RECEIPT DATE: 5/11/2023 **ONSITE SEWAGE DISPOSAL SYSTEM**

PROPERTY ADDRESS: 4890 Castlebridge Road

RE: 4890 Castlebridge
Carroll-Ziegler Property, Lot 5

SEPTIC PLAN
CARROLL-ZIEGLER PROPERTY, LOT 5
4890 CASTLEBRIDGE ROAD
ZONED: RC-DEO
TAX MAP NOS: 23 & 29 GRID NOS: 21, 22 & 3, 4 PARCEL NO: 29
THIRD ELECTION DISTRICT HOWARD COUNTY, MARYLAND
SCALE: AS SHOWN DATE: JUNE, 2018
SHEET 1 OF 1

See separate sheet for As-built

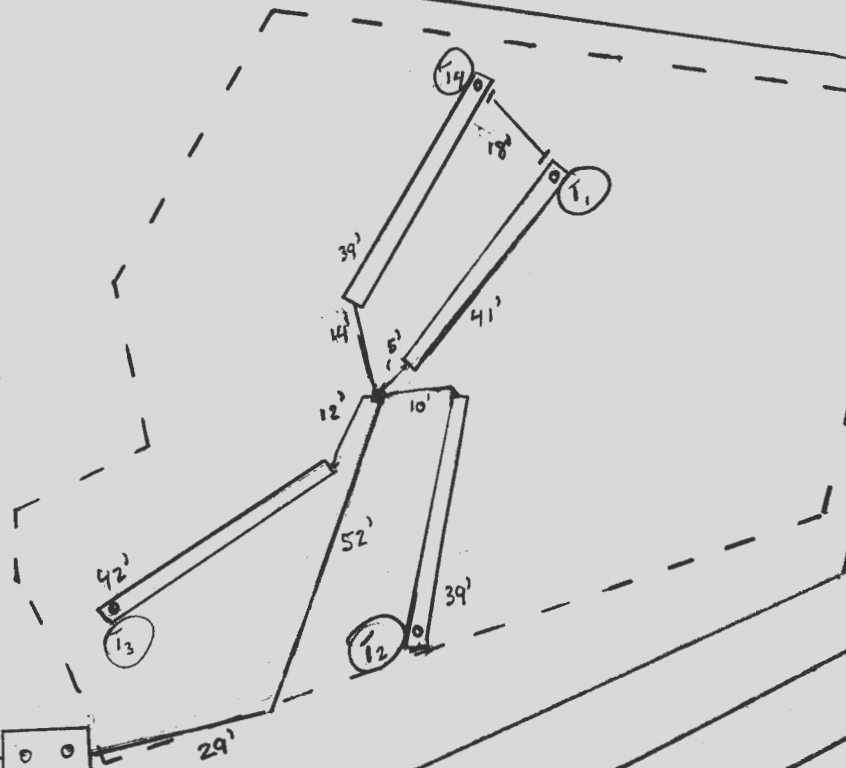
8/11/2023 met w/ Felt (Luke Knowles and Paul Case) on site. Found man described not as bad as indicated SPA statement was significantly diff. Will reuse PC + add plan. (SP)

11/8/2023 - Met contractor onsite for layout trench 1 obstructed by bushes & trench 2 has stones on top side not start trench 1 or 2. Shot elevation for trench 3, has 2" difference, straight per plan. Do not start trench 3 in this trench 2 needs to be moved. D-box moved 4' on to start install of outlet to d-box & trench 4. (SP)

11/27/2023 - Met w contractor. line from tank to d-box, installed & trench 4. trench 1, 2, & 3 laid out while onsite. All trenches on contour & lengths per plan. (SP)

11/28/2023 - trench 1, 2, & 3 finished. met @ 4' per plan. leveled d-box while onsite. on to backfill. (SP)

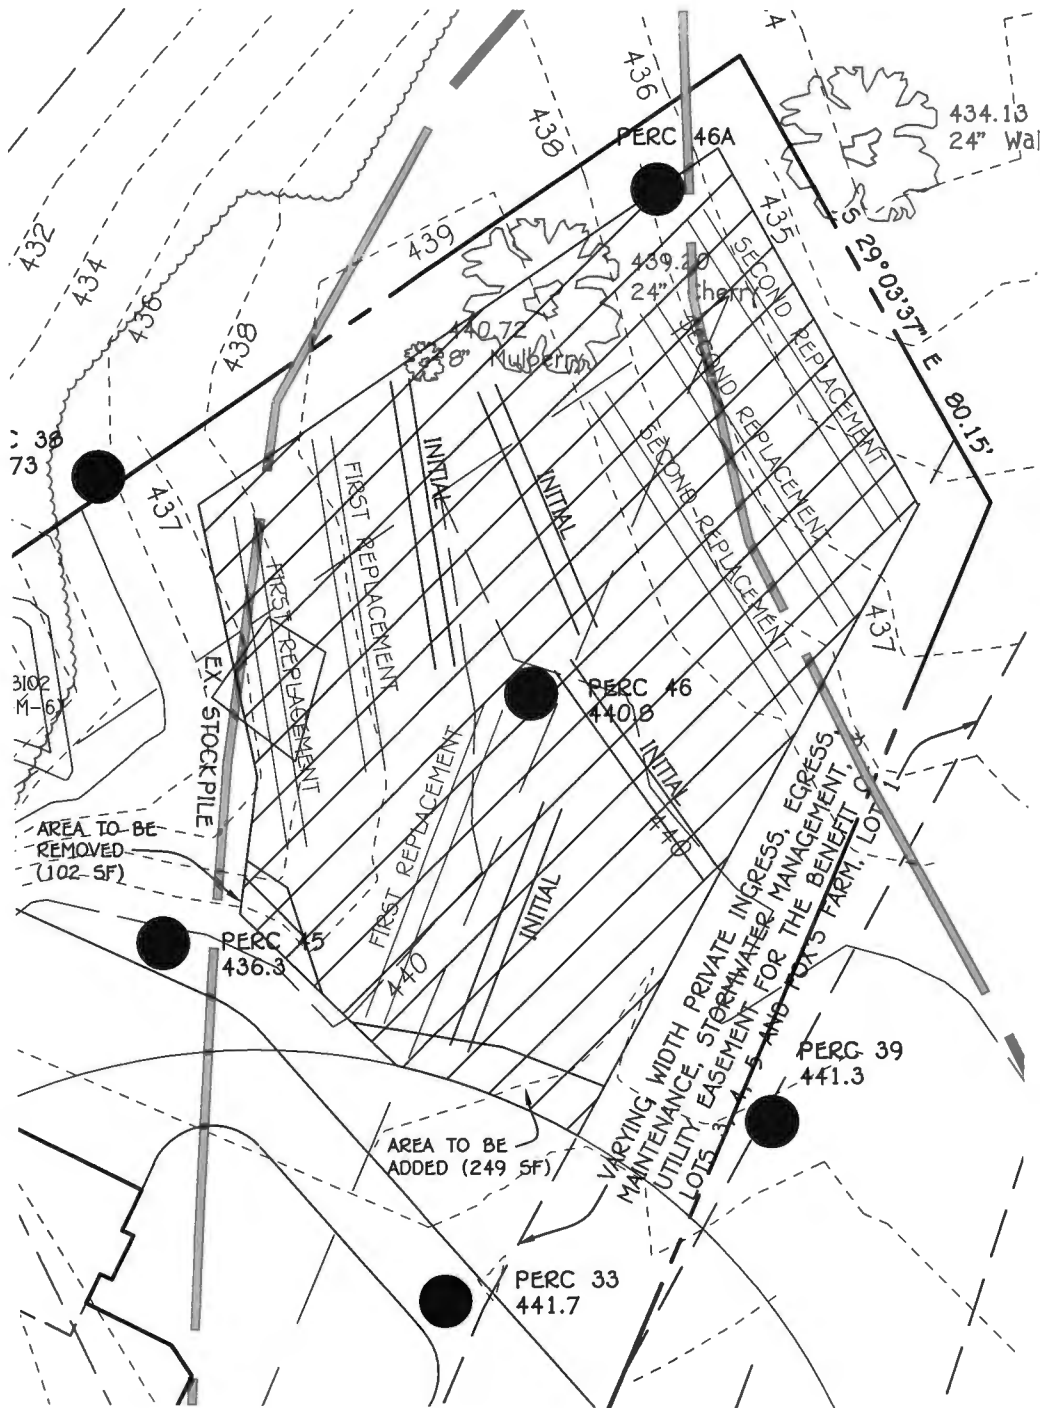
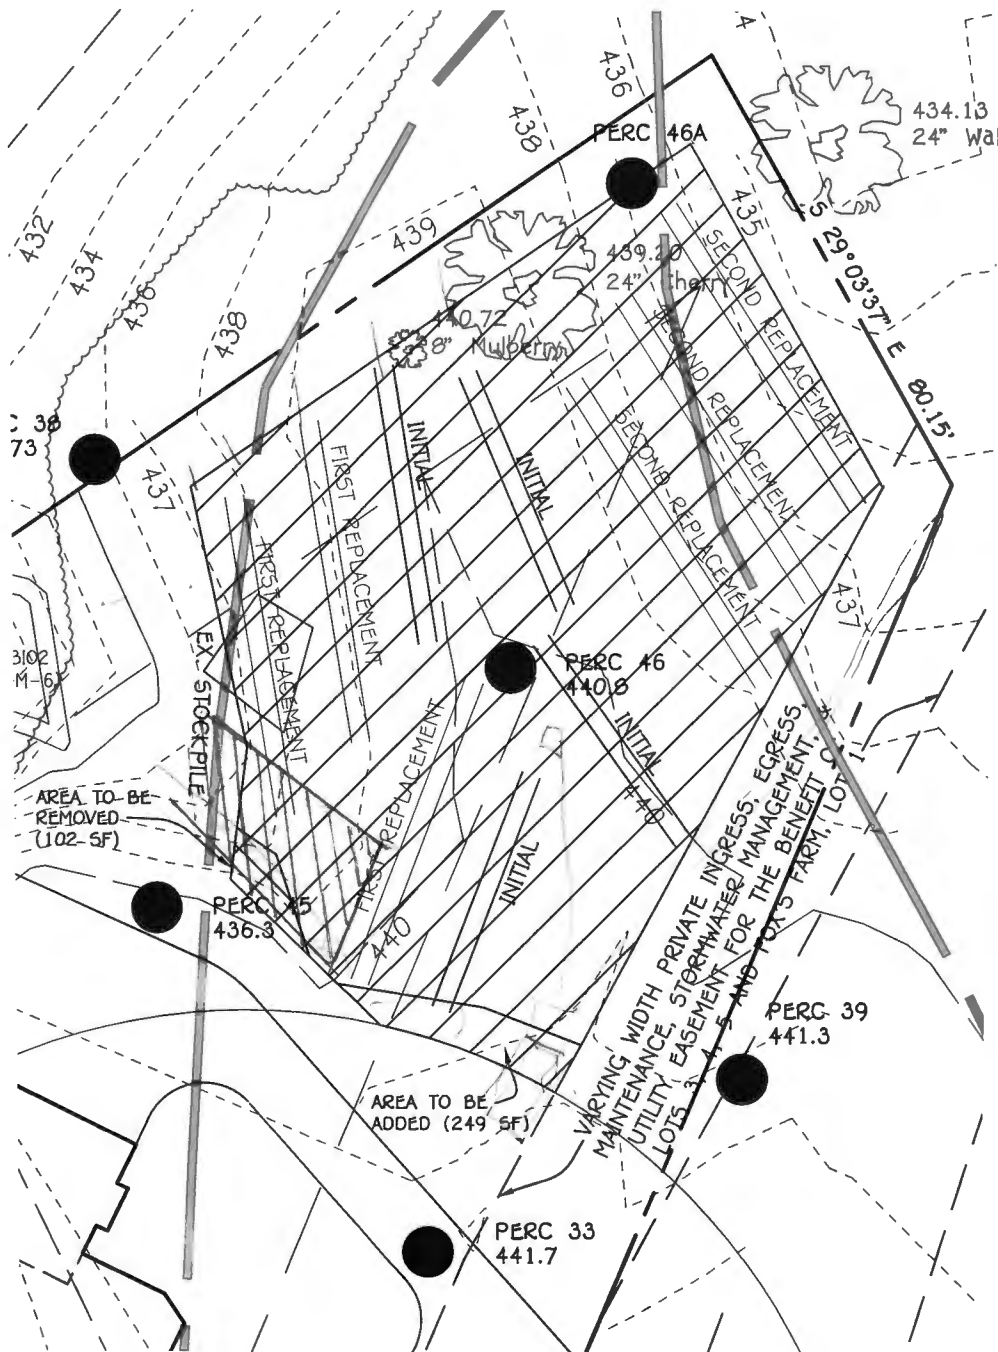
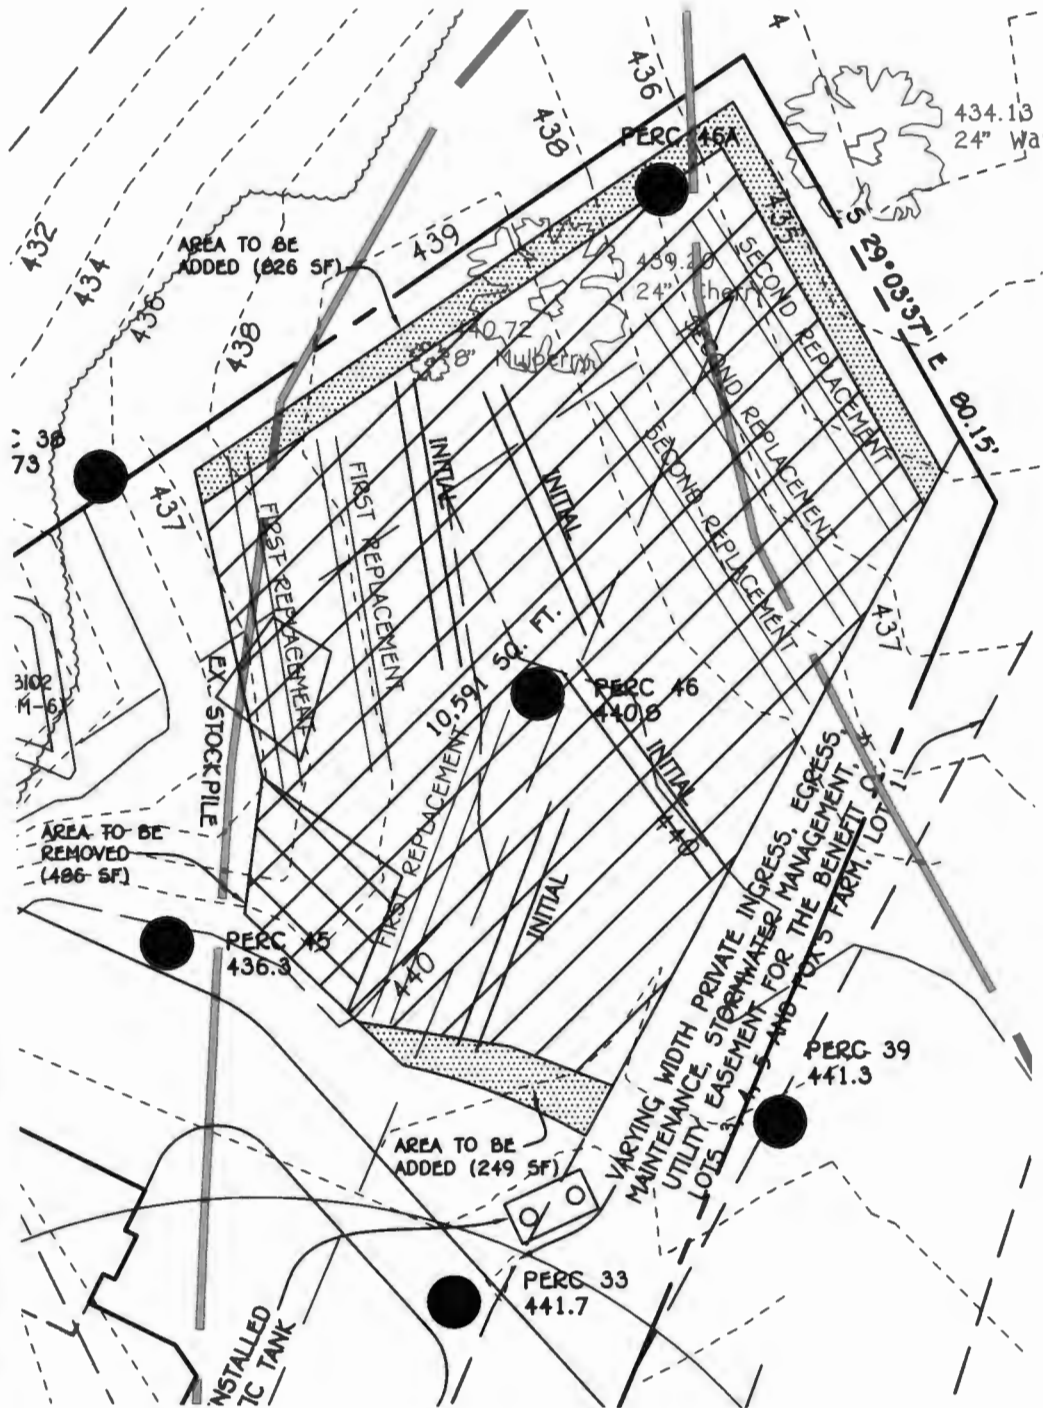
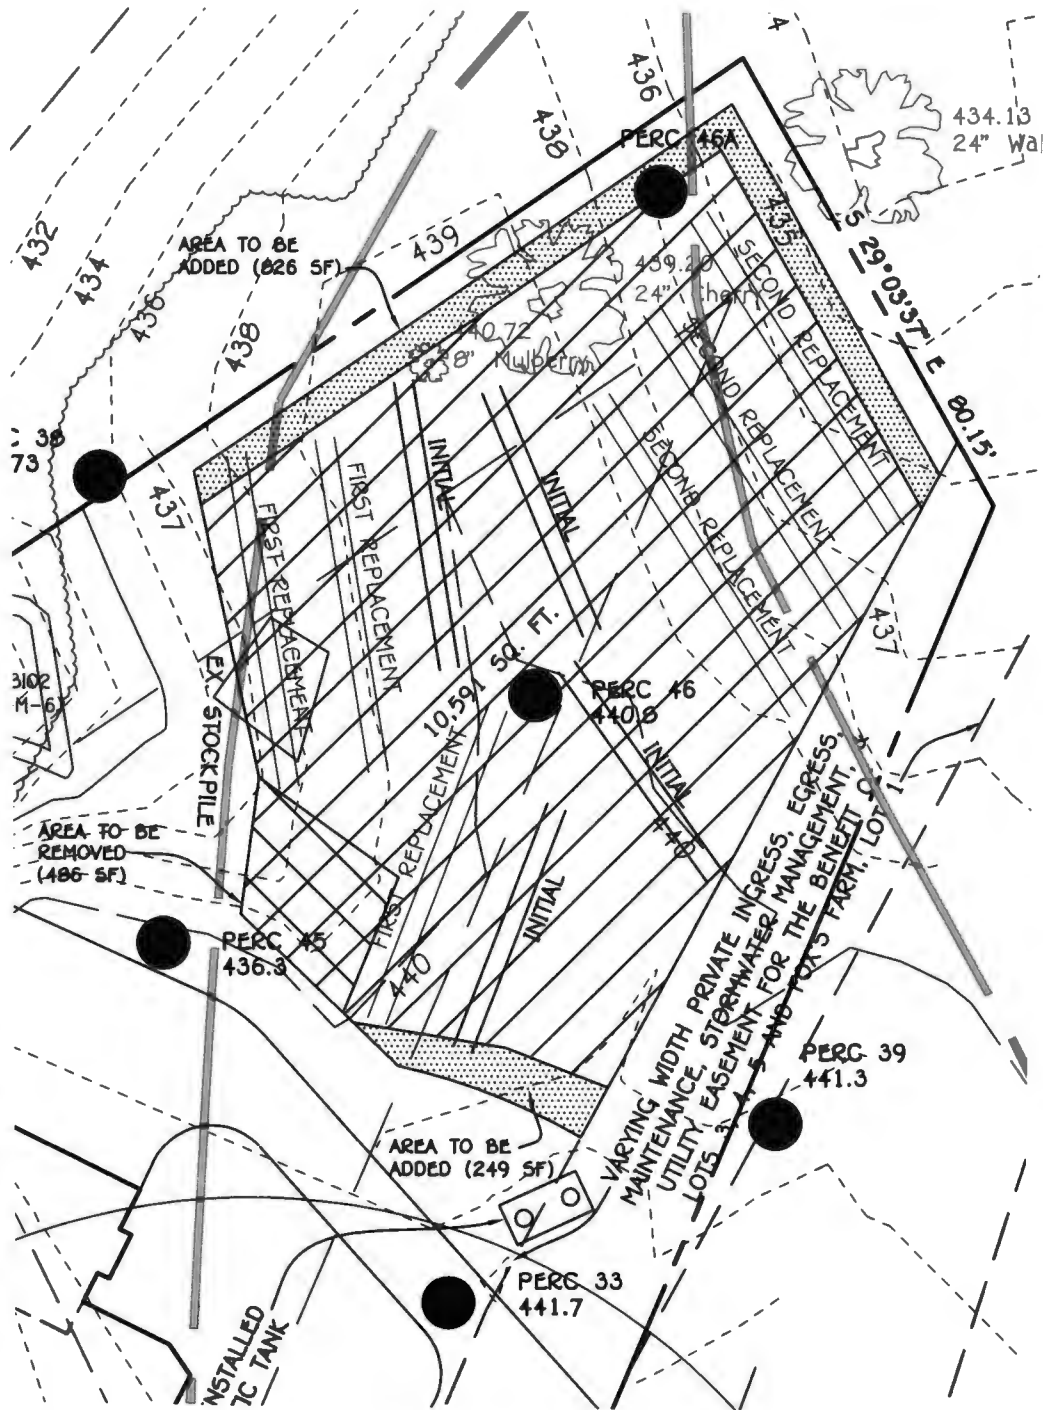
Has the SDA been re-staked by you all? I am asking because I am comparing what you have submitted to the original approved PC/OSDS plan and I see slight differences to what was staked in the field when we were last on site with the installer. I have revised the plan you submitted in your last email to reflect the area I believe has been compromised. The severity of the soil that was cut/taken out is deep enough rendering it unusable. The first replacement system will in deed need to be modified as such. I would also show the septic tank location as this has been installed per the original approved OSDS plan. The tank, if you recall, sits inside the SDA so the 249 sq ft additional area you show may not be available. You may consider moving 5ft towards the property line to gain more sq ft of sda but I would have to check with Jeff here that is still applicable in this situation. I will await the paper copies with the included notations mentioned above.

Based on our field investigation for the pre-construction meeting onsite with Young Septic, there were several issues found that need to be resolved before you can proceed further with the septic installation:

1. The sewage disposal area (SDA) was not properly staked according the approved OSDS plan/wall check survey plan.
2. The initial trench location elevations were shot in the field at the time of layout inspection with Young Septic. All 3 initial trenches (1A, 1B, 1C) were off contour by 8-12" respectively. We also measured the stakes and were found to be different lengths. We could not shift the trench locations per the approved OSDS plan so this will need to corrected. My recommendation is to have a 'field-run' topo performed along with 1 foot contours.

3. The area to the SW corner of the SDA has been compromised. Approximately 4-5 feet of native soil has been removed/cut out from this area which has now impacted the second replacement system trenches. The percolation plan (PC) will need to be revised with this area removed. The engineer will need to show a minimum 10,000 sq ft SDA that fits 3 systems. The site is very tight and space is limited so it will take some engineering to redesign.

We are submitting paper prints of the attached Perc Recertification Plan and Trench Exhibit to your attention. The Perc Recertification Plan now has field-run 1-foot contours in the area of the sewage disposal area (SDA).

We have revised the sewage disposal area (SDA) to remove the compromised SW corner and add additional area to maintain >10,000 square feet. The Trench Exhibit is to demonstrate the revised SDA fitting three systems.
